DART AEROSPACE LTD	Work Order:	119706
Description: Crosstube Assembly (205/212 High Aft)	Part Number:	D212-664-241
Inspection Dwg: D212-664-241 Rev: D		Page 1 of 2

DESIGN	PH	DART AEROSPACE LTD	
DRAWN	RF	HAWKESBURY, ONTARIO, CANADA	
CHECKED	98	DRAWING NO.	REV. D
MFG. APPR.	18	D212-664-241	SHEET 3 OF 4
APPROVED	19	TITLE	SCALE
DE APPR.	11	CROSSTUBE ASS'Y (205/212 HI AFT)	NTS
DATE	09.09.30	<small>COPYRIGHT © 2000 BY DART AEROSPACE LTD THIS DOCUMENT IS PRIVATE AND CONFIDENTIAL AND IS SUPPLIED ON THE EXPRESS CONDITION THAT IT IS NOT TO BE USED FOR ANY PURPOSE OR COPIED OR COMMUNICATED TO ANY OTHER PERSON WITHOUT WRITTEN PERMISSION FROM DART AEROSPACE LTD.</small>

DRAWING NO. D212-664-241	TITLE CROSSTUBE ASSY (205/212 HI AFT)	REV. D	DART AEROSPACE LTD. ENGINEERING ORDER		D.E.O. NO. D212-664-241-D-1	SHEET NO. SHEET 1 OF 2	SCALE NTS
DRAWN	CHECKED	MFG. APPR.	APPROVED	DE APPR.			
DATE 11.04.07	DATE 11.04.11	DATE 11.04.12	DATE 11/04/12	DATE 11.04.12

DRAWING NO. D212-664-241	TITLE CROSSTUBE ASS'Y (205/212 HI AFT)	REV. D	DART AEROSPACE LTD ENGINEERING ORDER		D.E.O. NO. D212-664-241-D-2	SHEET NO. SHEET 1 OF 1	SCALE NTS
DRAWN <i>q</i>	CHECKED <i>ASS</i>	MFG. APPR. <i>DS</i>	APPROVED <i>MD</i>

**D212-664-241/-241B
ASSEMBLY DETAIL**

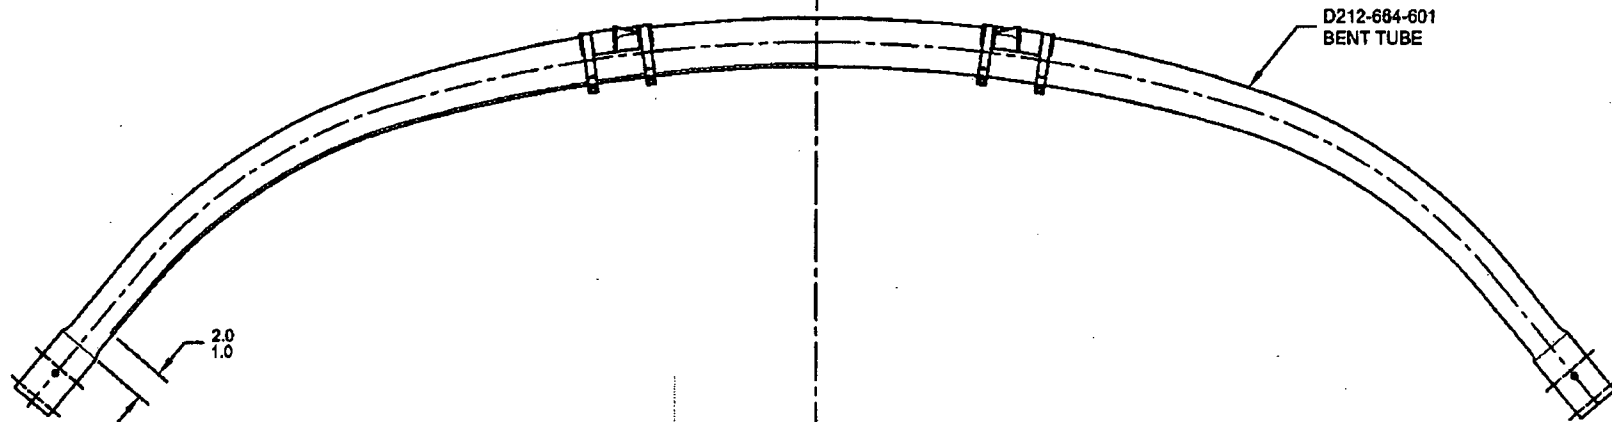
PURPOSE:

ADD AN INSPECTION WINDOW TO UNDERSIDE OF CROSSTUBE.

NOTES 2 OF SHEET 1 IS AMENDED AS FOLLOWS:

IS:

WAS:

IS:

- 2) FINISH: CHEMICAL CONVERSION COAT PER DART QSI 005 4.1
PRIME INSIDE AND OUTSIDE PER DART QSI 005 4.2
MASK UNDERSIDE OF CROSSTUBE AS SHOWN (HATCHED AREA) AND
PAINT OUTSIDE PER DART QSI 005 4.2
REMOVE MASKING AND APPLY CLEAR COAT

MASK AREA PRIOR TO PAINTING,
REMOVE MASKING AFTER PAINT
AND APPLY CLEAR COAT
